Docket Item # 15
BAR CASE #2005-0303

BAR Meeting
February 1, 2006

ISSUE: Concept approval of 2 new buildings

APPLICANT: AFBA

Figure 1 Proposed site plan

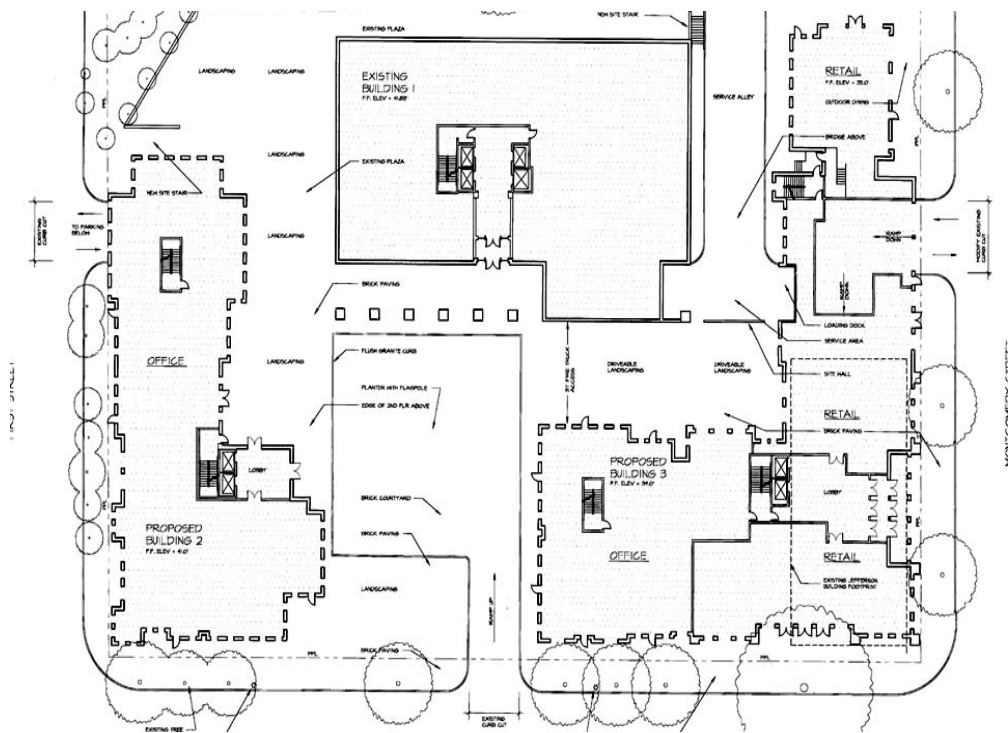
- F-1 Proposed structures shall be kept under 50 feet in height, otherwise ladder truck access will be required. The elevation drawings depict several structures ranging in height from 60 to 65 feet. These structures will require ladder truck access. This access is not currently provided in this concept plan submission.

- F-2 The proposed modification to the existing fire access upon addition of the proposed structures shall meet the following criteria: Fire / Ladder Truck Access shall be required to the two longest sides of each structure. This requires a truck to be able to position itself between 15 and 30 feet from the face of the building. All elevated structures used for this purpose shall be designed to AASHTO HS-20 loadings. The proposed access appears to be too close to the existing building near the southwest quadrant of the structure. Turning radii within the fire access lane shall be R-25 minimum. The width of the travel lane shall be 22 foot minimum. Provision for turning fire apparatus around shall include 60 foot deep pockets. These pockets may be part of the fire access lane. The width of the proposed fire access road appears to be less than 22 feet in width. Is the line shown dividing the auto court from the fire access road a separate elevation. What measures are intended to permit fire apparatus to cross the auto court into the fire access road. Turning radii has not been provided, but appear to be far less than the R-25 minimum requirement. Show the limits of the fire access road. As shown on the plans, the lines fade off the drawing.

Figure 2 Proposed North Washington Street elevation looking east

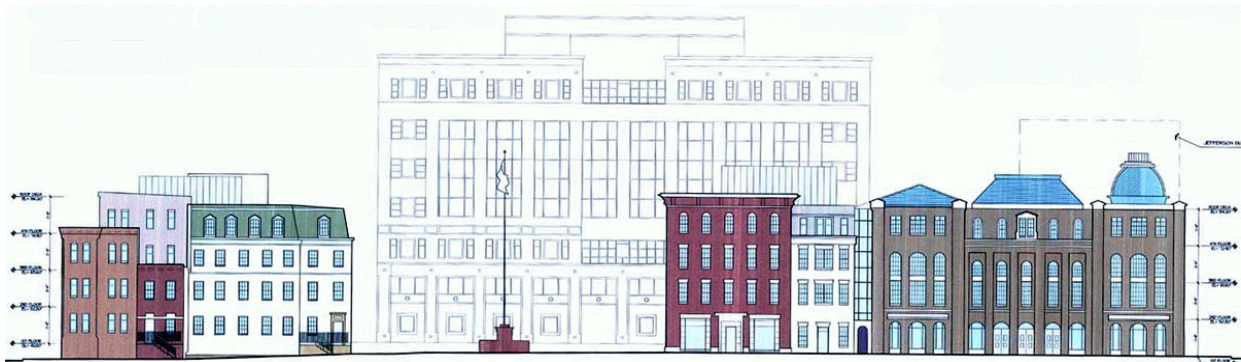
- a. Revise the massing of the building as the corner of North Washington Street and Montgomery Street as outlined above.
- b. Eliminate the glass connector element.
- c. Provide the exterior elevations for the internal courtyard.
- d. Revise the Mansard-roof building adjacent to the courtyard to read more as a “building.”
- e. Lower the height of the base of the buildings at the corner of North Washington Street and First Street.
- f. Study the possibility of an increased setback at the corner of North Washington Street and First Street to provide a setback more compatible with the adjacent building.

Figure 3 Proposed Montgomery Street elevation looking north

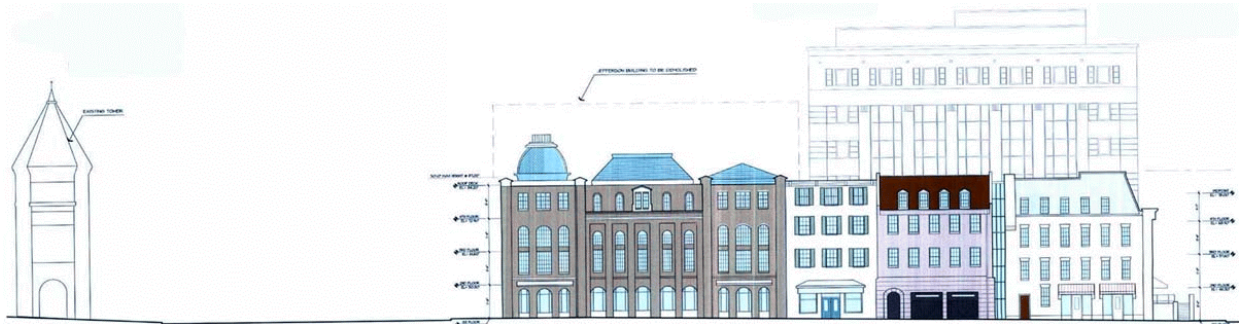
- a. Provide additional detail on the retail bays.
- b. Eliminate the glass connector element.
- c. Provide North St. Asaph Street elevation.
- d. Refine the garage entrance.
